Town of Hilton Head Island
Design Review Board Meeting
Tuesday, January 12, 2021 – 1:15 p.m.
AGENDA

Town of Hilton Head Island
Design Review Board Meeting
December 8, 2020 at 1:15 p.m. Virtual Meeting
MEETING MINUTES

**THE TOWN OF HILTON HEAD ISLAND
DESIGN REVIEW BOARD – NOTICE OF ACTION**

DESIGN TEAM/DRB COMMENT SHEET

Sheet #:
LS-1.0

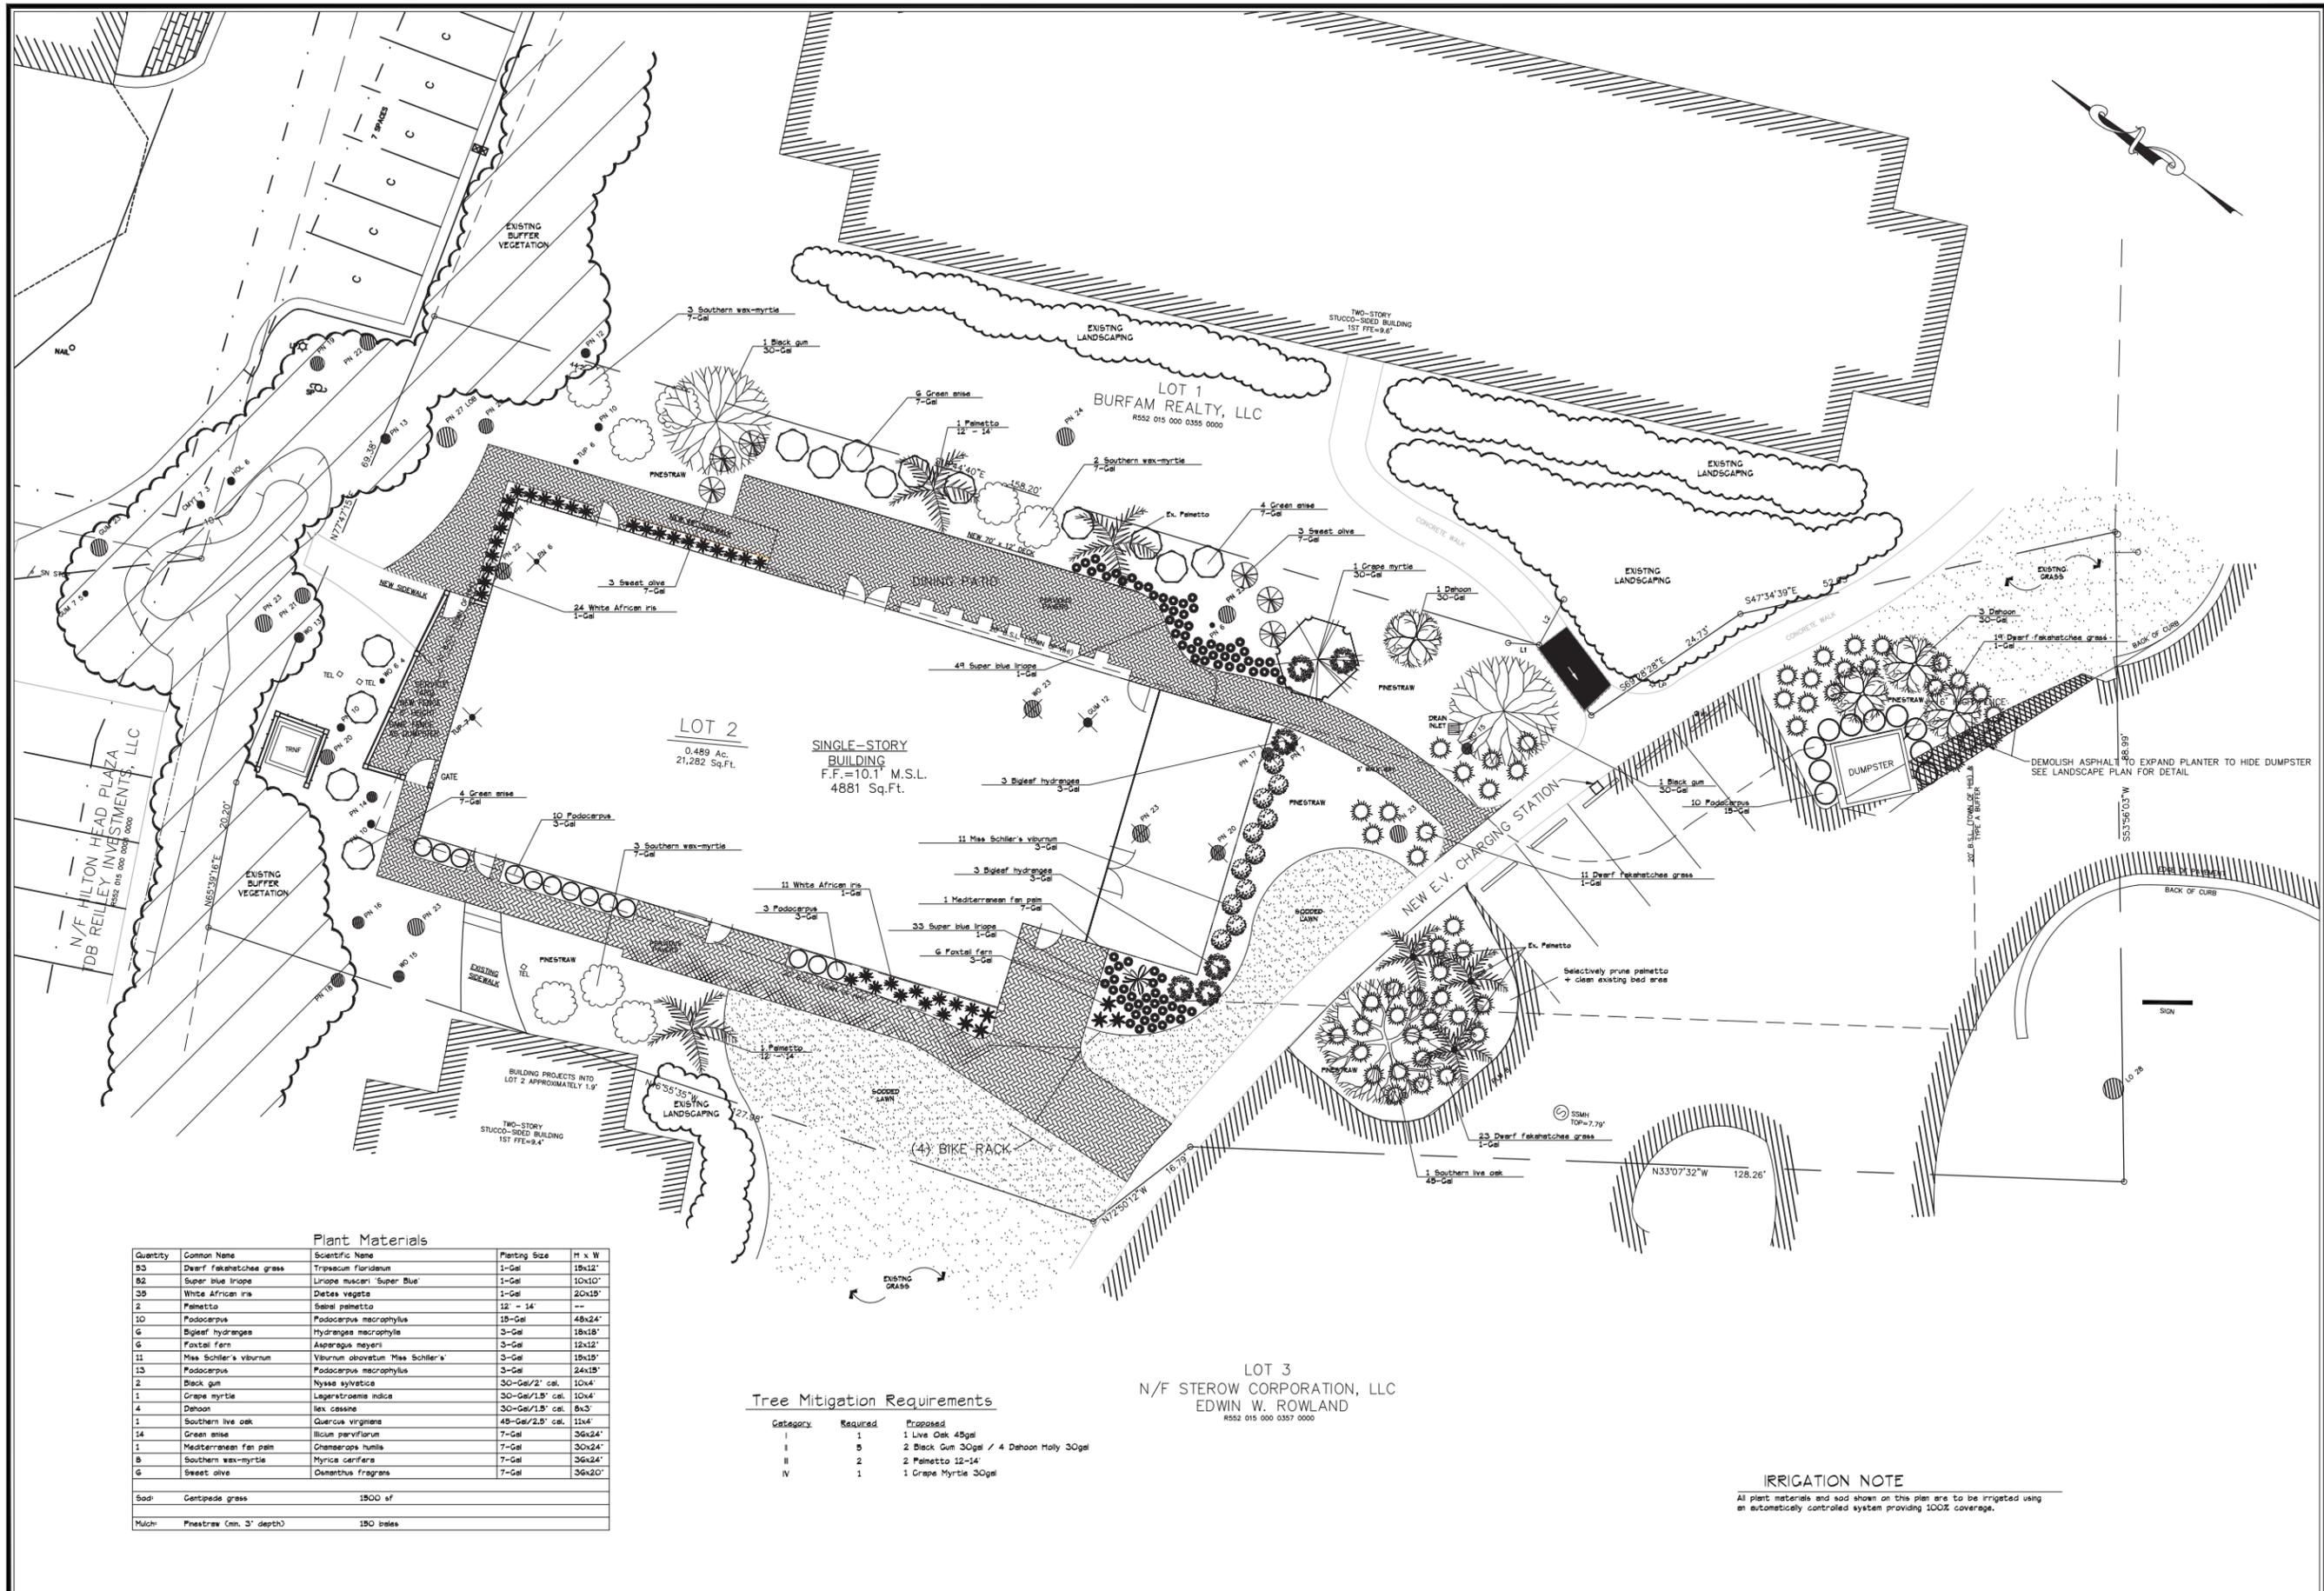
DESIGN GUIDE/LMO CRITERIA	Complies Yes	No	Not Applicable	Comments or Conditions
Treats the Landscape as a major element of the project	<input type="checkbox"/>	<input checked="" type="checkbox"/>	<input type="checkbox"/>	There are areas that are not addressed.
Provides for a harmonious setting for the site's structures, parking areas or other construction	<input type="checkbox"/>	<input checked="" type="checkbox"/>	<input type="checkbox"/>	Simplify the plant palette.
Proposed groundcovers are evergreen species with low maintenance needs	<input type="checkbox"/>	<input checked="" type="checkbox"/>	<input type="checkbox"/>	It appears it may be too shady for the Muhly Grass to survive as located. Replace with Dwarf Fakahatchee Grass or Liriope.

DESIGN GUIDE/LMO CRITERIA	Complies Yes	No	Not Applicable	Comments or Conditions
Supplemental and replacement trees meet LMO requirements for size, species and number	<input type="checkbox"/>	<input checked="" type="checkbox"/>	<input type="checkbox"/>	Provide the caliper for planted trees to determine if the required tree planting has been met.

DRAWN BY
 TP
CHECKED BY
 DATE
 12/28/20
SCALE
JOB NO.
SHEET
C.0
 OF SHEETS

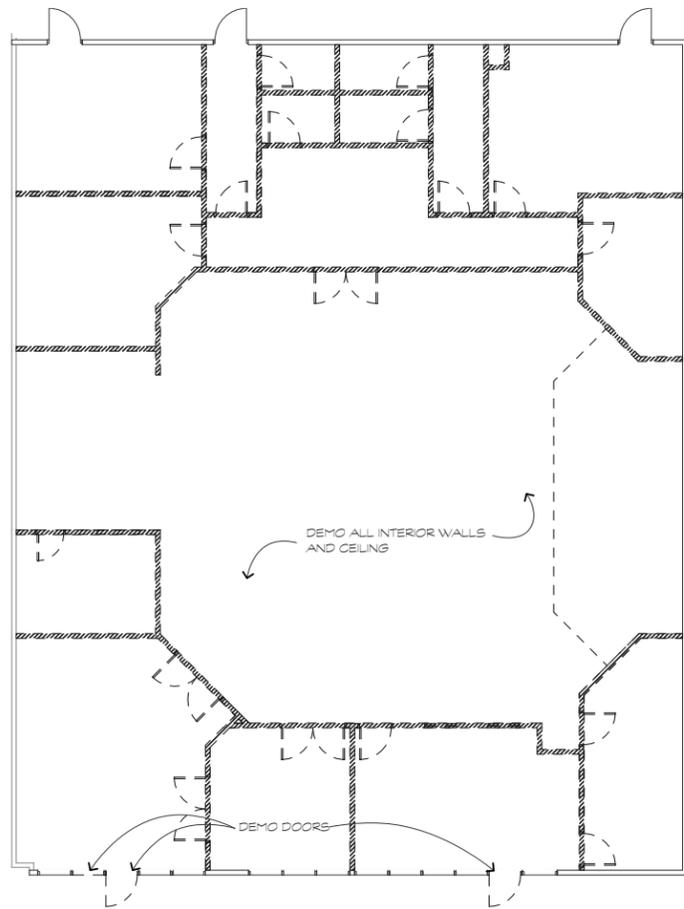
bronze color is too dark relative to the existing building; not in favor of the chain link fence; clarify how the existing structure will be modified and the new structure will fit; update C.0 to show the existing deck in the corner will remain; clarify whether the drainage goes from the paved area into the landscape buffer; consider alternate color and material options perhaps stucco in place of the metal.
